SERVICE BULLETIN

NUMBER:	SB 500-33-001, REV A
MODEL:	ECLIPSE EA500
SUBJECT:	LANDING LIGHT BALLAST LOCATION INSPECTION/REWORK

To increase the life of the landing light and the ballast.

This Service Bulletin provides the procedure to inspect and relocate the ballast within the landing light cannister, if necessary.

Landing Light Ballast Rework
Figure 1

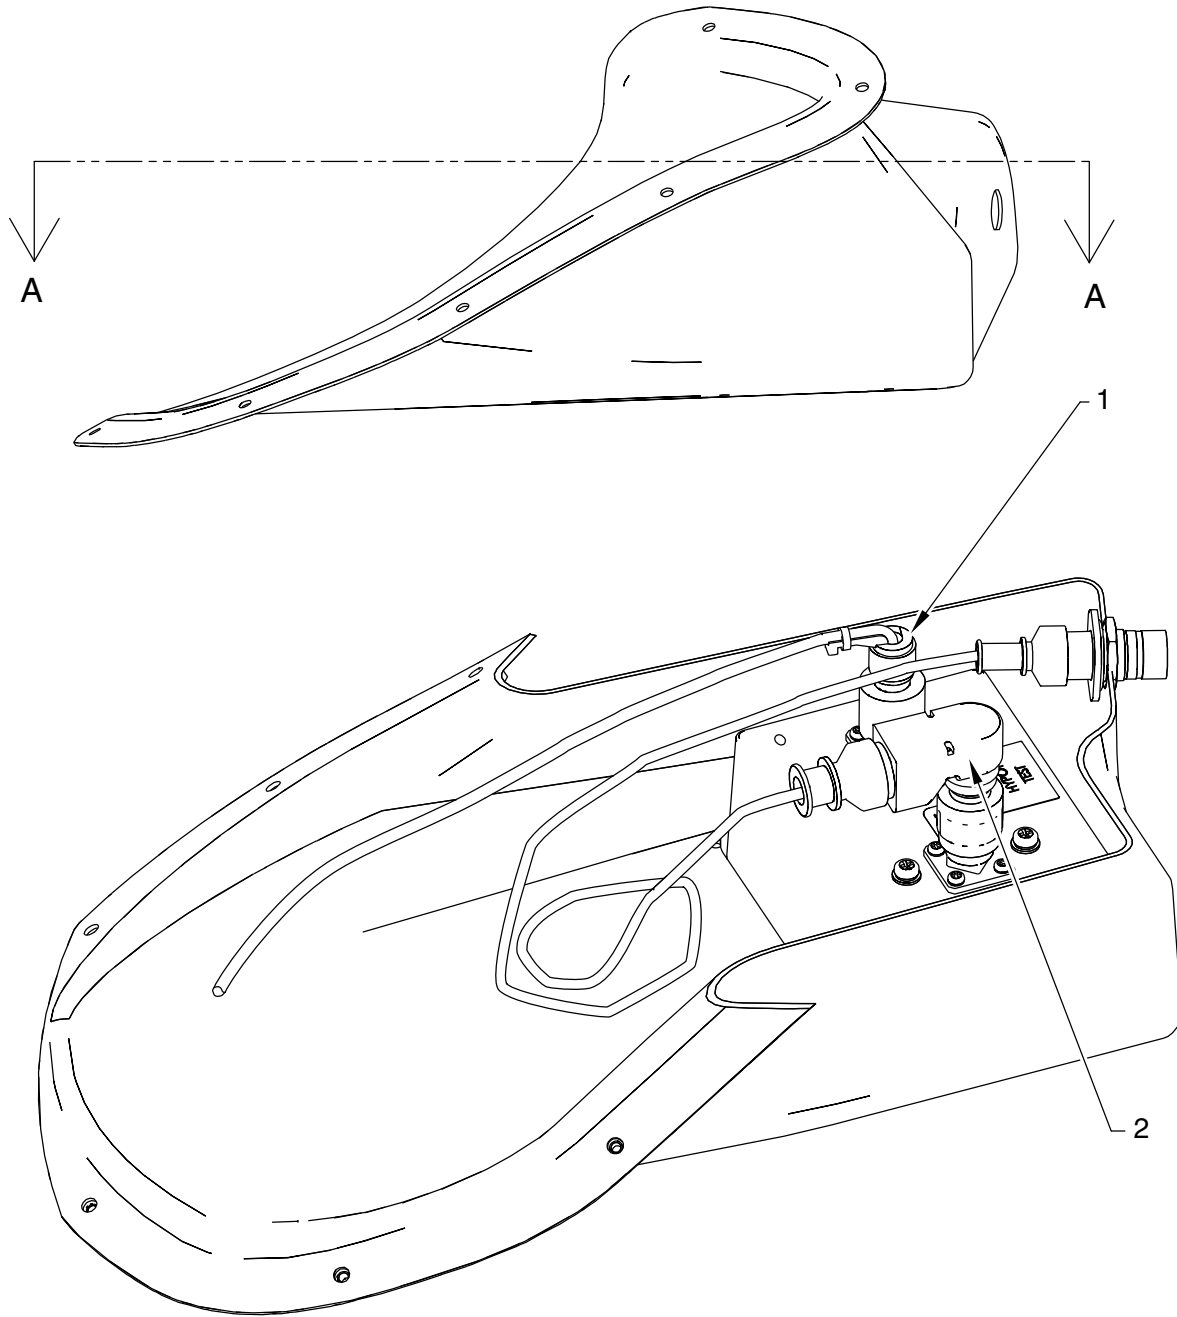
- (3) Inspect left and right Landing Light Canister for 1.25 inch (REF) distance from aft ballast mounting hole to the exterior back of canister. Refer to [\(REF\) Detail A, Figure 1](#).
NOTE: The Landing Light Ballast does not need to be removed to measure the REF dimension. Measure from the center of the fastener to the outside edge of the cannister.

- (4) Remove affected left and/or right Landing Light Ballast. Refer to AMM 33-40-19 BALLAST, LANDING LIGHT - REMOVAL.
- (5) Locate and drill four 0.176 diameter holes into landing light cannister. Refer to [Figure 1](#).

- (6) Fill original holes (X4) ([Flag Note 1](#), [Figure 1](#)) with PPG Aerospace (PRC-DeSoto) PR-2001, Type 2, Class B sealant. Build up sealant a minimum of 0.05 inch above the surface of the cannister on both sides. Sealant must extend beyond the edge of hole onto the cannister surface a minimum of 0.03 inch.
NOTE: Allow sealant to cure before installing the ballast.

- (7) Mark cannister with indelible ink at location ([Flag Note 2](#), [Figure 1](#)) "Part Modified per SB 500-33-001".
- (8) Re-clock electrical connector backshells ([1 and 2](#), [Figure 2](#)) as shown for both left and right sides.
